LOCAL HISTORIC DISTRICT:	Dilworth
ADDRESS OF PROPERTY:	909 Romany Road
SUMMARY OF REQUEST:	Addition
OWNER:	Owen Bugge and Roshean Ham
APPLICANT:	Angie Lauer/ALB Architecture

Revised Proposal-May 21, 2014

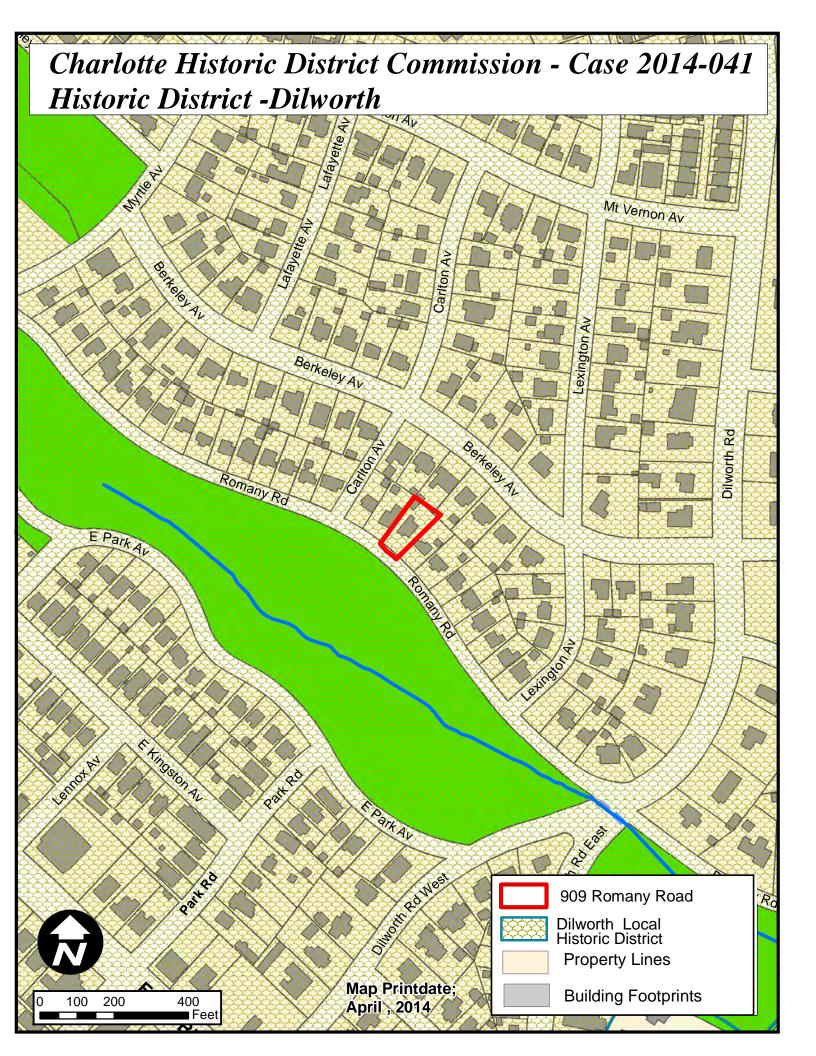
- Massing of the gable
- Window in the front gable
- Fenestration on front second floor
- Left elevation

The following changes were made based on comments from April (Massing and Fenestration):

- 1. Second story windows changed to casement. Change to set of three windows in the front gable.
- 2. Addition of vents in gables.
